Permitting decisions - Refusal

We have decided to refuse the variation application for United Utilities Blackburn Wastewater Treatment Works (WwTW) operated by United Utilities Water Limited, application number: EPR/XP3638LJ/V005 (the Application).

The existing permit number is EPR/XP3638LJ.

Figure 6 – EEH Reactor No. 6 Tank Burst

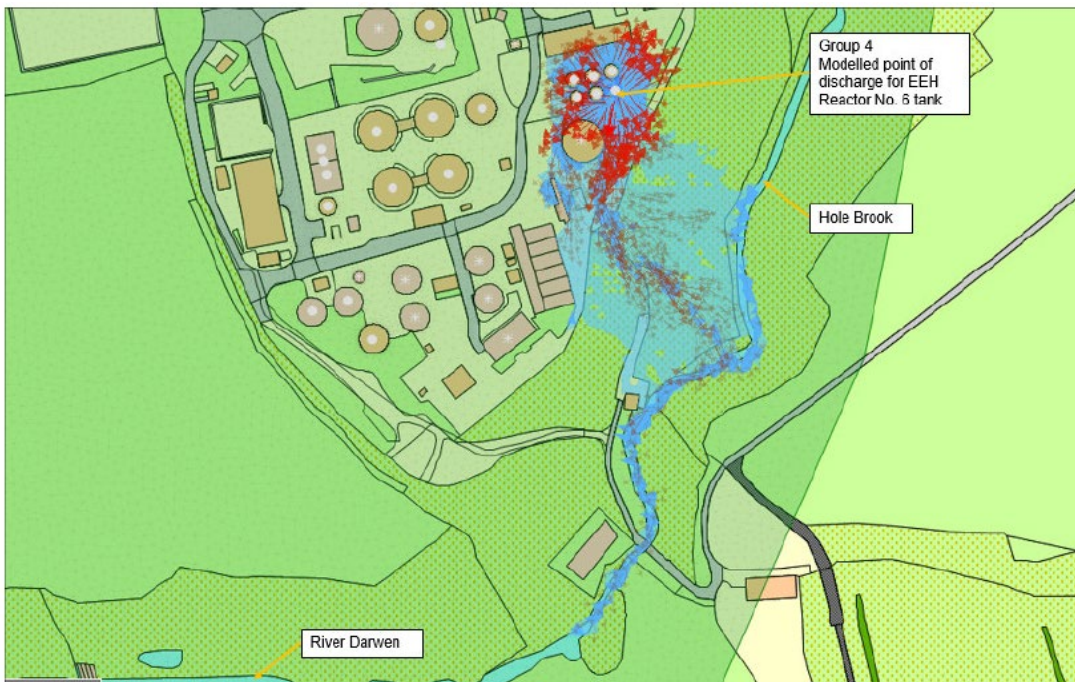
- Some assets were allocated a risk of harm score of 0 as the Applicant determined that the source-pathway-receptor linkage had been broken. This included the EEH Reactors No, 1 - 6, which were allocated a score of 0 for leak likelihood based on mitigating factors being in place to reduce the leak likelihood. No explanation of mitigating factors in place was provided apart from the indication in the score allocation. This score directly conflicted with the spill modelling report which showed that a tank failure would leave the Site boundary and enter Hole Brook, feeding directly into the River Darwen.

Figure 8 – Applicants proposed containment solution

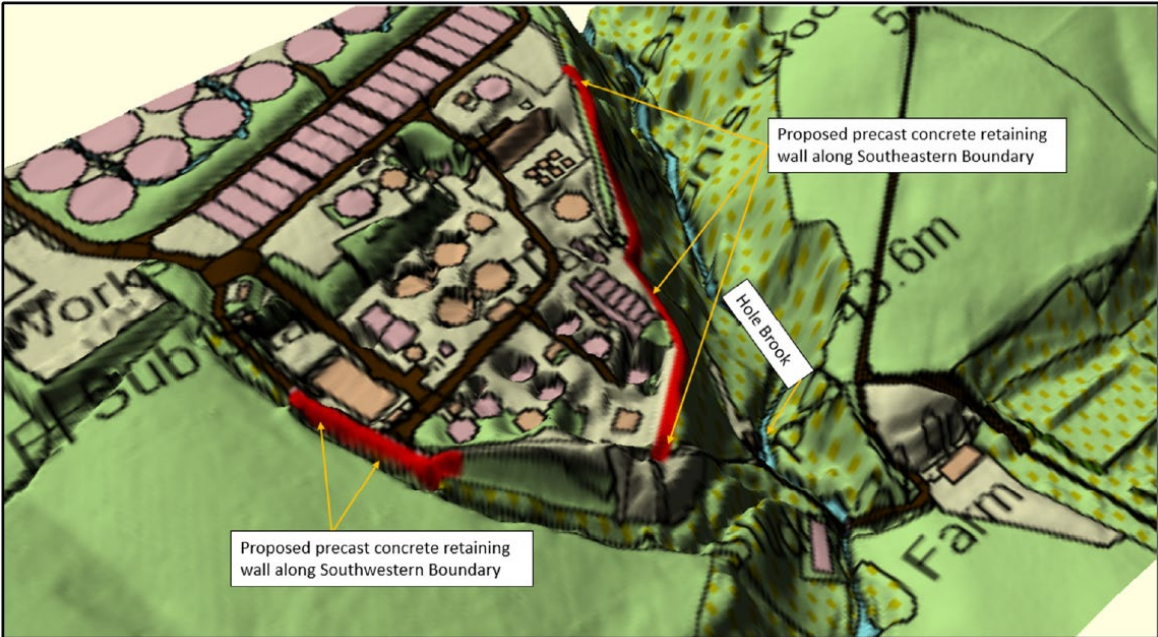
On assessment of this solution the "*proposed pre-cast concrete retaining wall*" (identified as a red line on figure 8 above), would have contained a spill within areas identified in the Site surfacing plan as "Grass / Soft Landscaping", and "Mixed surfacing e.g. gravel with concrete" which have not been identified as impermeable surfaces. No calculations were provided to demonstrate that the solutions proposed would allow for the containment of 110% of the largest tank, or 25% of the total volume of the tanks, and no spill modelling has been undertaken to demonstrate the impacts of a tank failure following the implementation of the Site improvements identified. It was also identified that the solution provided in figure 16 by the Applicant did not include proposals to contain tanks identified in Group 5 which were identified as reaching receptors.

The proposals lacked the detail required for us to adequately assess improvements, they did not explain or provide information on existing containment in place, they did not address failures in tanks included and not included in the spill modelling, and they were not run through the spill modelling to show the impact following implementation or installation of the proposed solutions/improvements.
